NAME: JOAN M. MOONEY
APPLICATION APPEAL 19-0107

AAD NO. 20-003/WRA

FRESHWATER WETLANDS REVIEW SHEET

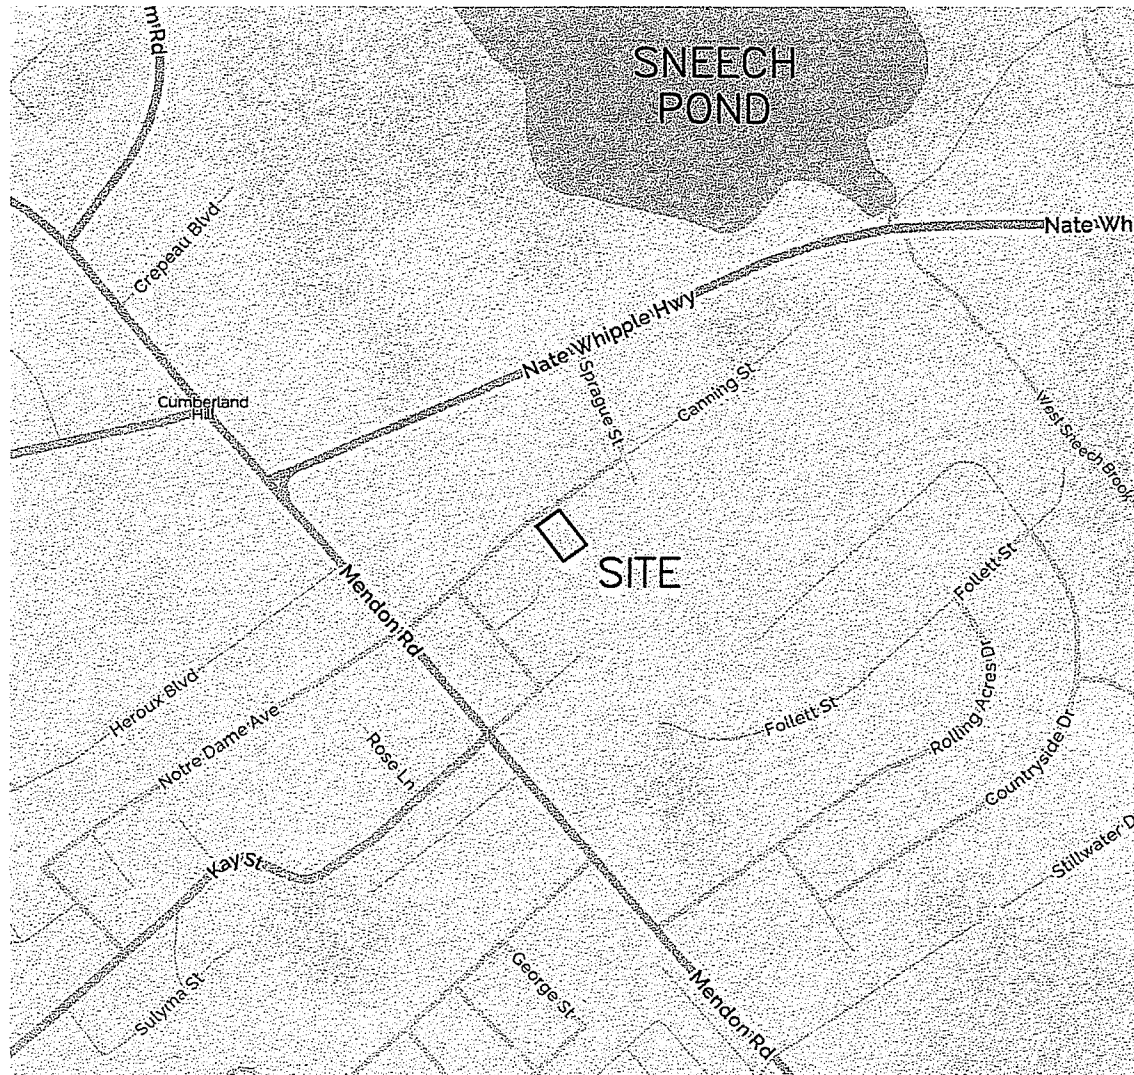
Please note that this Department has not verified the wetland edges that are illustrated on the submitted site plan. The swamp has been determined to extend further upslope into the interior of the subject property than is shown on the site plan.

The swamp edge has not been flagged on or adjacent to the subject site. Site plans depict an approximate wetland edge offsite. Hydrophytic vegetation [Appendix 2A of the Rules And Regulations Governing The Administrative And Enforcement Of The Fresh Water Wetlands Act, July 16, 2014] (Rules) observed on the subject site within the approximate depicted proposed limit of disturbance includes but not limited to: red maple (*Acer rubrum*), ash sp. (*Fraxinus* sp.), elm sp. (*Ulmus* sp.), arrowwood (*Viburnum dentatum*), dogwood (*Cornus* sp.), elderberry (*Sambucus canadensis*), grape sp. (*Vitis* sp.), poison ivy (*Toxicodendron radicans*), jewelweed (*Impatiens capensis*), and jack-in-the-pulpit (*Arisaema triphyllum*).

Deciduous trees, deciduous saplings, shrubs, vines, herbaceous plants, and other vegetation along with patches of exposed soil were observed within the 50 foot perimeter wetland. The depicted 50 foot perimeter wetland edge is considered inaccurate due to the swamp edge extending further upslope into the interior of the subject property than shown.

Area Subject To Storm Flowage (ASSF)

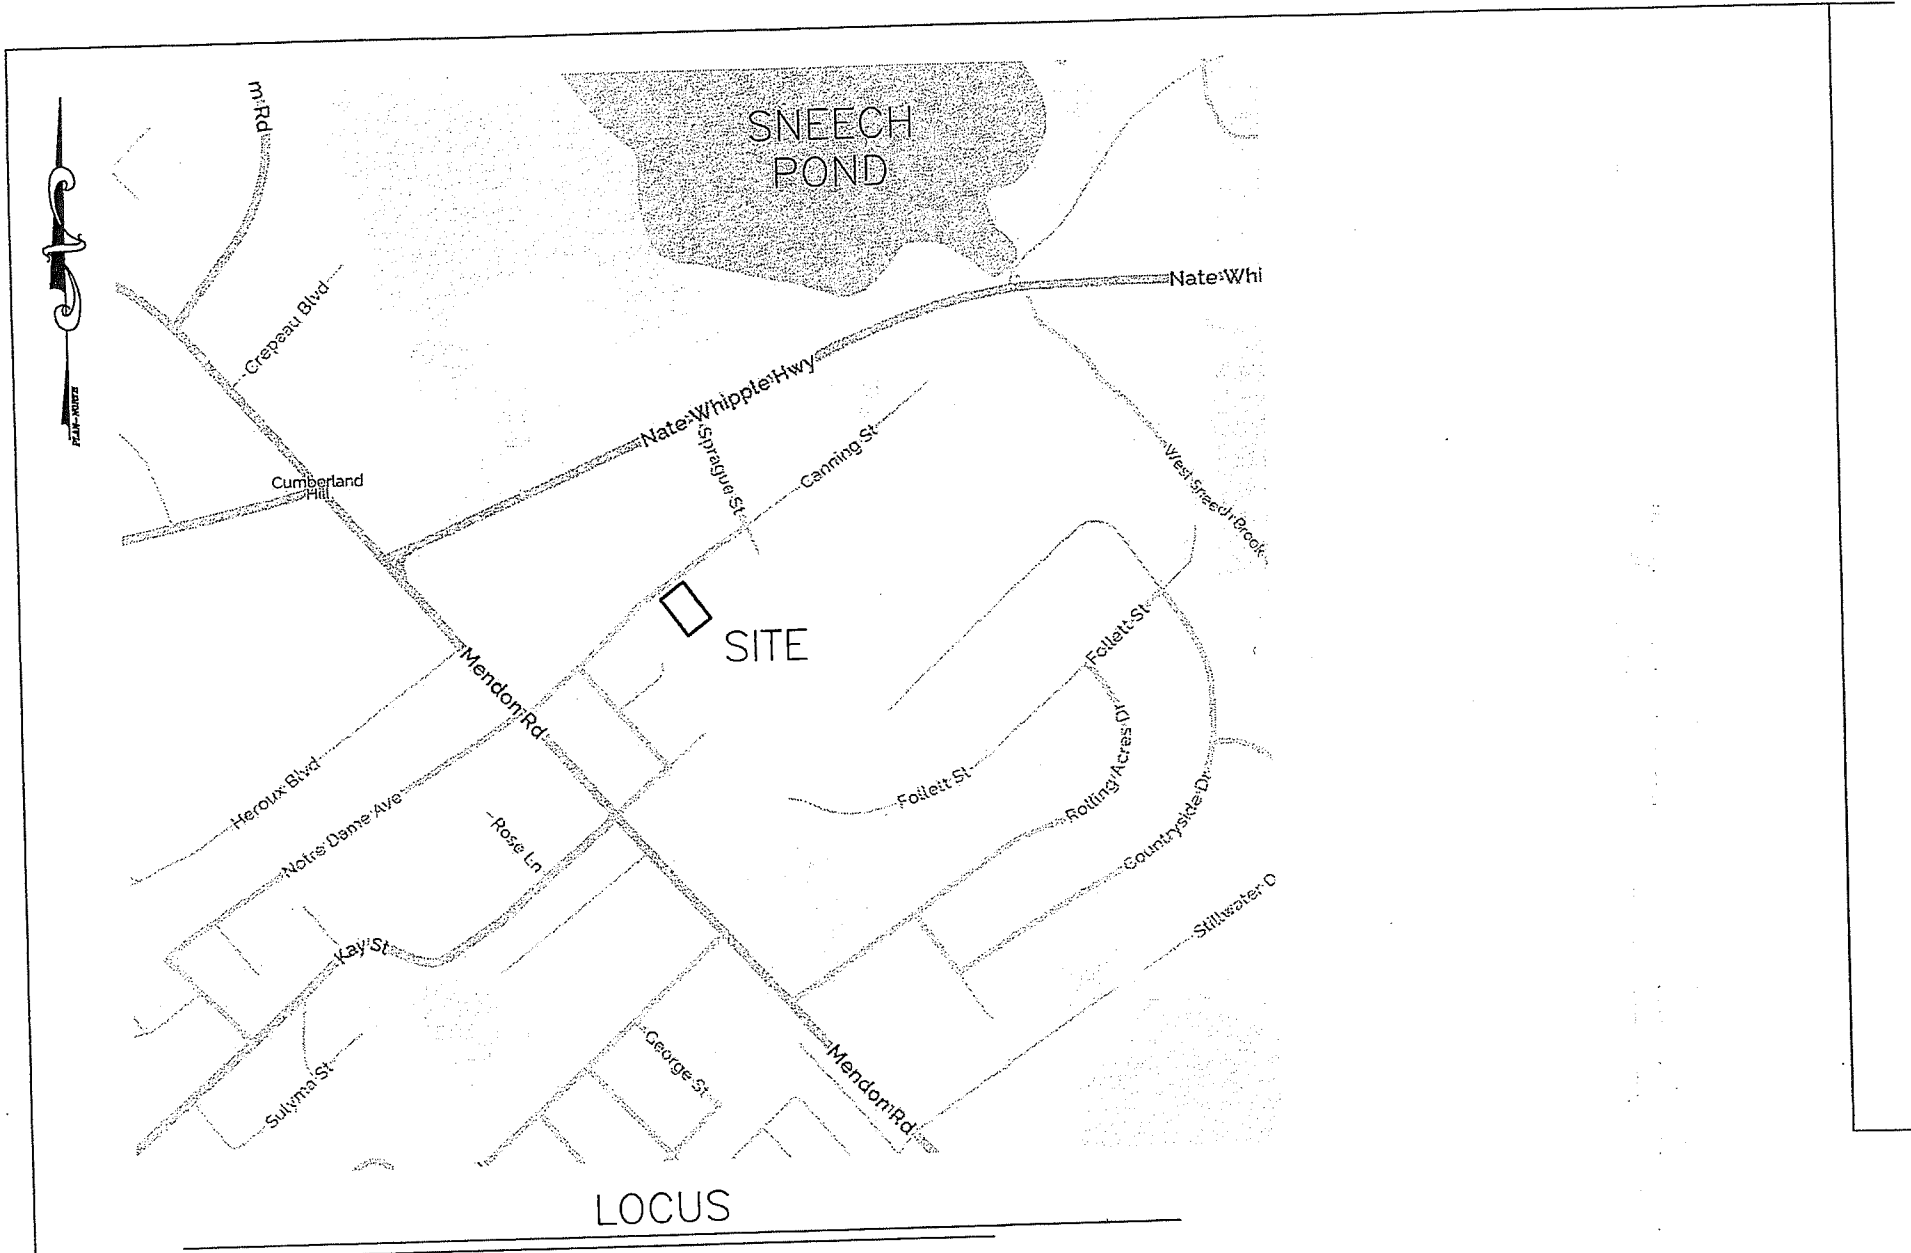
An ASSF is present that originates at Canning Street and extends into the interior of the subject site into the swamp. The ASSF is demarcated by a deposit of sediment along a slightly scoured channel. This ASSF appears to convey local stormwater runoff to the subject swamp. This ASSF has not been shown on the site plan.
